# **PRELIMINARY/FINAL DRAINAGE REPORT**

### **CROSSROADS MIXED USE FILING NO. 2 EL PASO COUNTY, COLORADO**

NOVEMBER 2022

**FINAL DRAINAGE REPORT  
FOR  
CROSSROADS MIXED USE FILING NO. 2**

# CROSSROADS MIXED USE FILING NO. 2

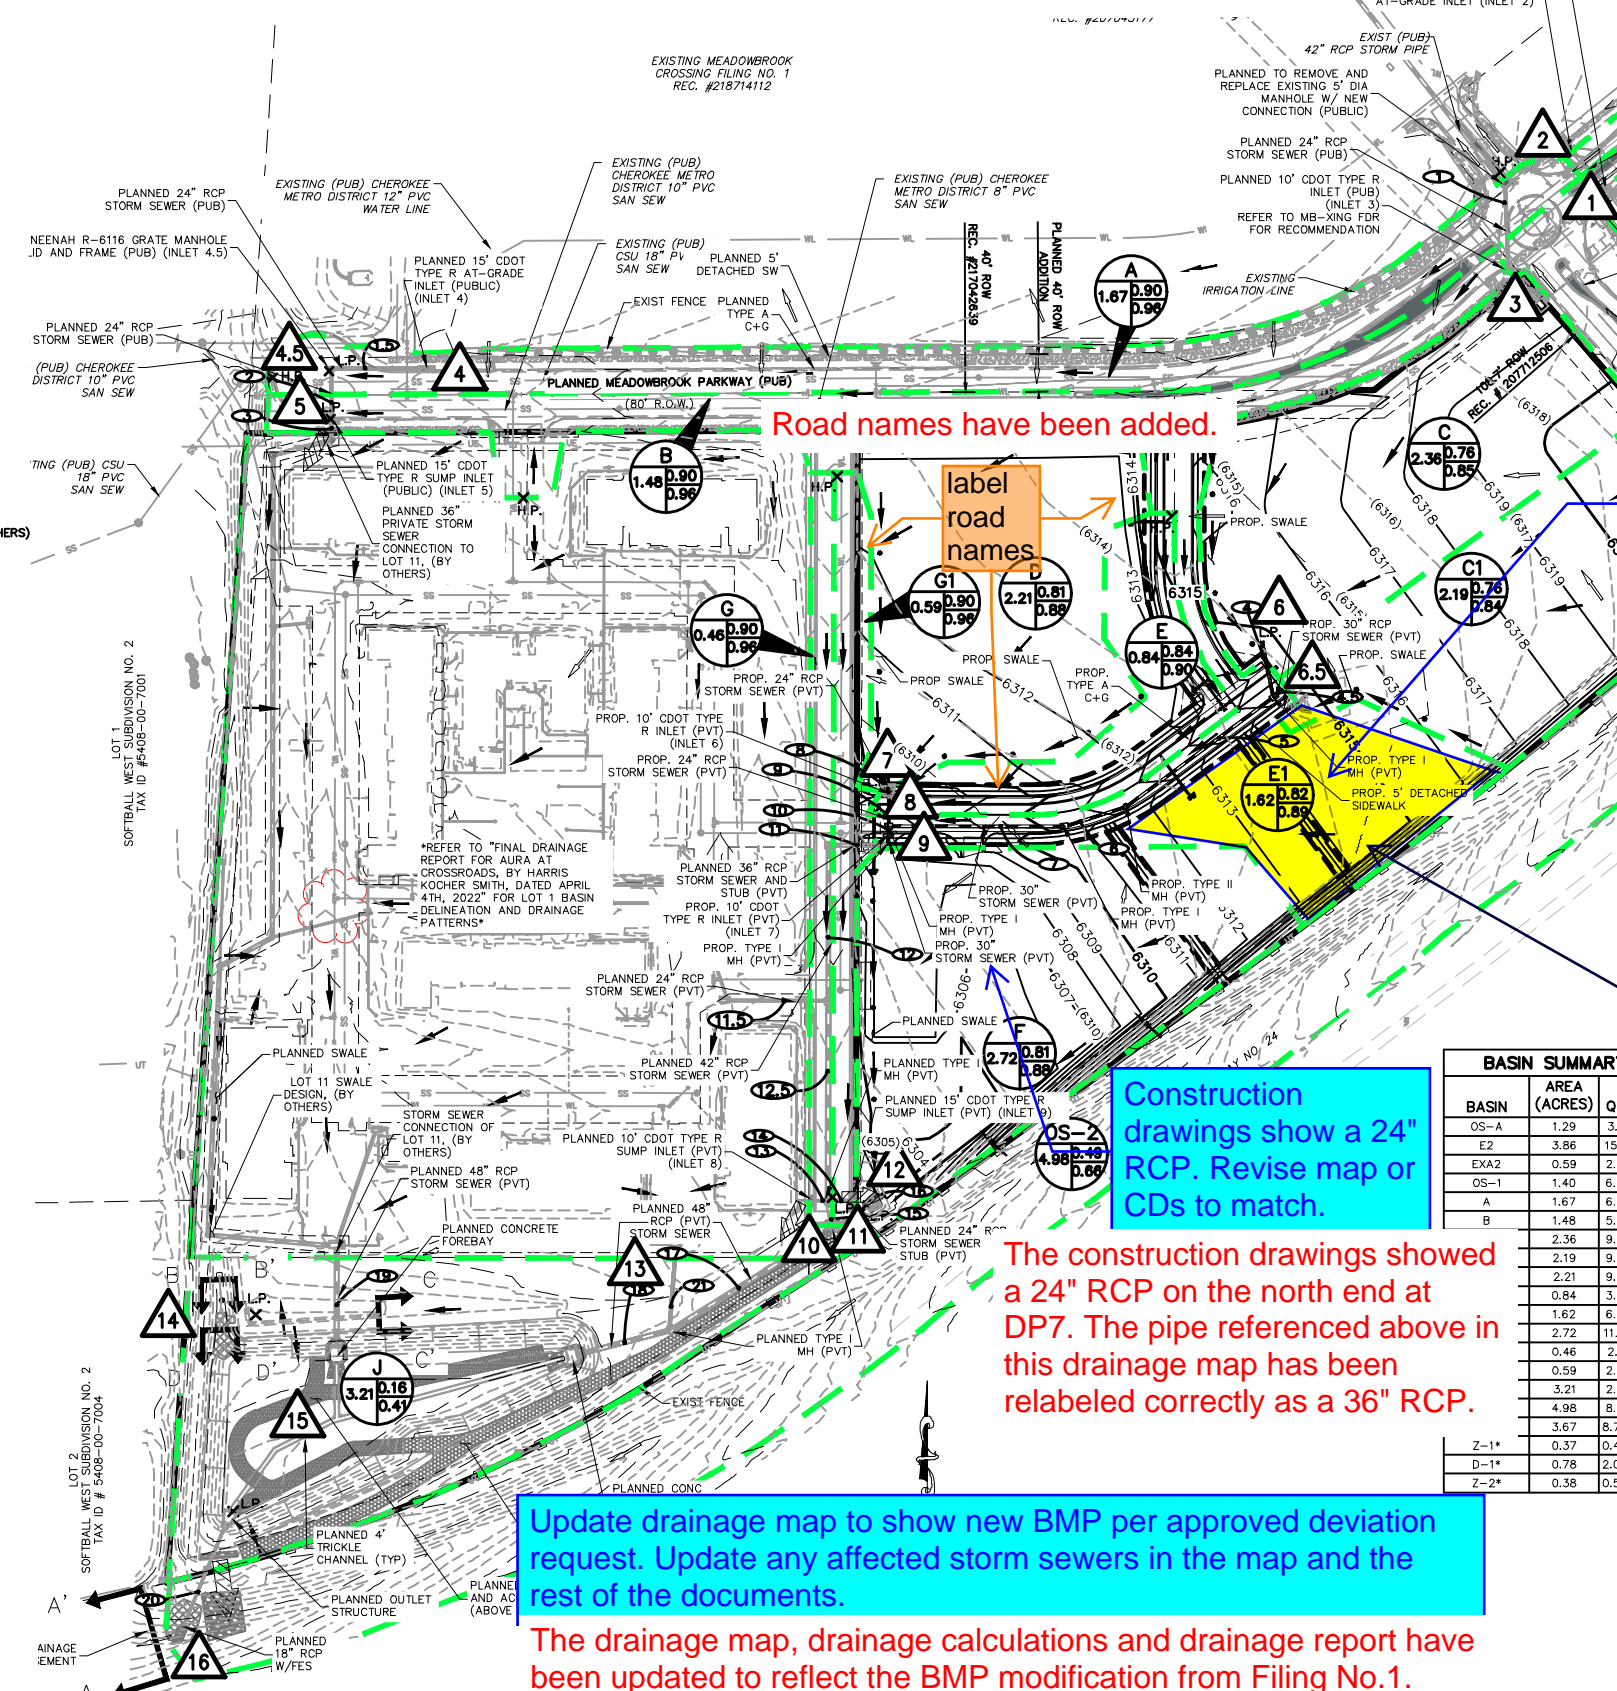
Construction drawings show a 24" RCP. Revise map or CDs to match.

Update drainage map to show new BMP per approved deviation request. Update any affected storm sewers in the map and the rest of the documents.

There are several inconsistencies between these drainage map and CDs proposed conditions. These include: labeling of private and public storm sewer, mismatched pipe sizes, and missing proposed swales. Coordinate with CD engineer to remove inconsistencies between the two documents.

Clarify what "planned" improvements mean. Staff is assuming "Planned" are proposed improvements constructed with filing 1.

Based on the proposed contours adjust Basin F boundary to include the highlighted area or provide an explanation on the DP9/Basin E1 description on how this is supposed to drain to the inlet at DP9 (Based on the proposed grading this doesn't seem possible)

Road names have been added.

The drainage map, drainage calculations and drainage report have been updated to reflect the BMP modification from Filing No.1.

This was considered, however the amount of sheet flow that would exit the site to the roadway is approximately 3 cfs during 100-year event and the flows do not drain off of the lots to the same single point. The Lot 1 & 2 drainage report discusses this in detail.

The staff's assumption of "planned" improvements is correct and has been clarified in the drainage map and report text.
